Invention: VARIABLE BUOYANCY BUOY FOR MOORING MOBILE
OFFSHORE DRILLING UNITS

PETITION TO WITHDRAW A HOLDING OF
ABANDONMENT UNDER 37 C.F.R. § 1.181

AMENDMENT AFTER FINAL

Fig.10

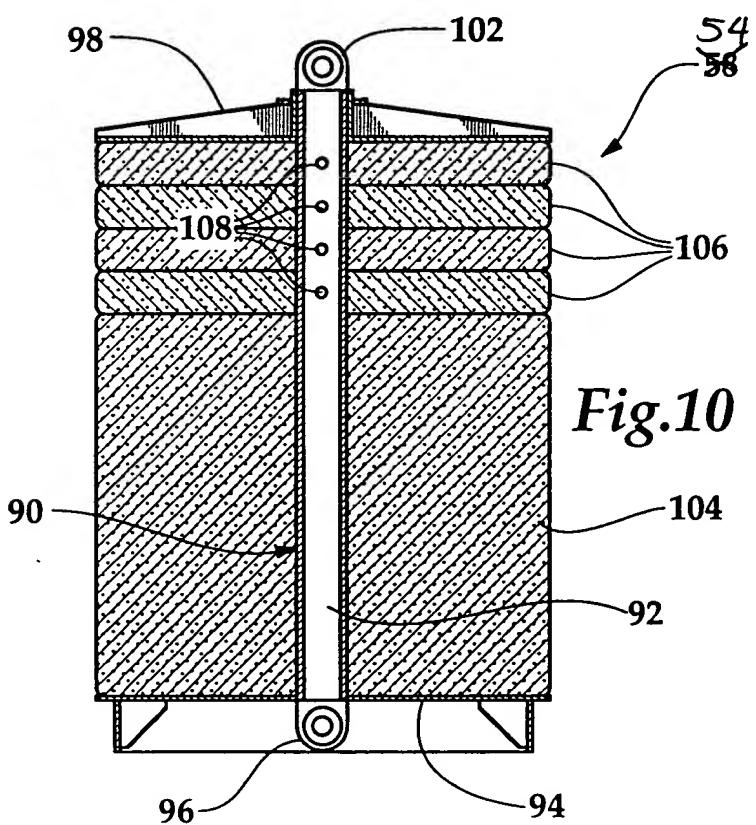
In Fig. 10, the reference number 58 is replaced with 54 to properly refer to "buoy 54." This amendment conforms Fig. 10 to Figs. 2 and 3 and related specification page 16, in which 54 refers to the variable buoyancy buoys and 58 refers to interconnecting mooring line 58. The specification has been corrected throughout so that erroneous references to "buoy 58" has been changed to correct references to -- buoy 54 --. To extent that Applicant was able to detect, any such misnumbered references to the variable buoyancy buoy 54 correction was made.

Drawings with proposed corrections in red ink are submitted herewith for consideration and review by the Official Draftsperson. In the event the application is passed to issue, formal corrected drawings will be submitted upon approval by the Official Draftsperson.

Fig.12

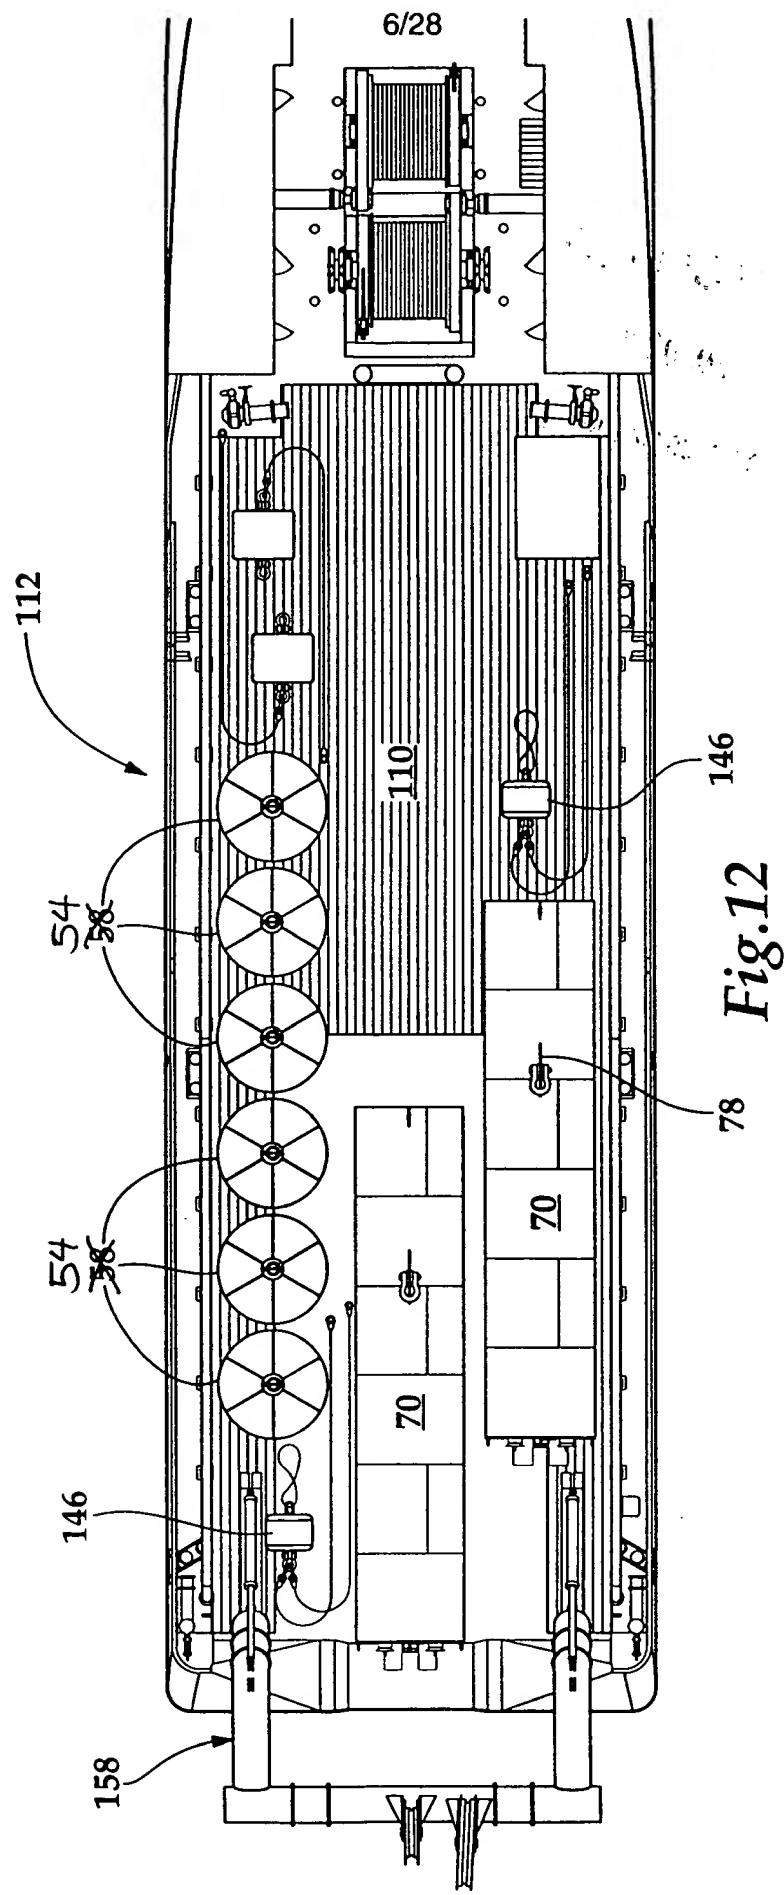
Fig. 12 has similarly been corrected, replacing reference to buoys 58 to the correct reference to buoys 54. No new matter has been added by these conforming amendments and no new search should be required pursuant to this amendment. Moreover, this amendment places the application in a better condition for allowance and/or a better condition for appeal. Entry of this amendment after final is deemed proper.
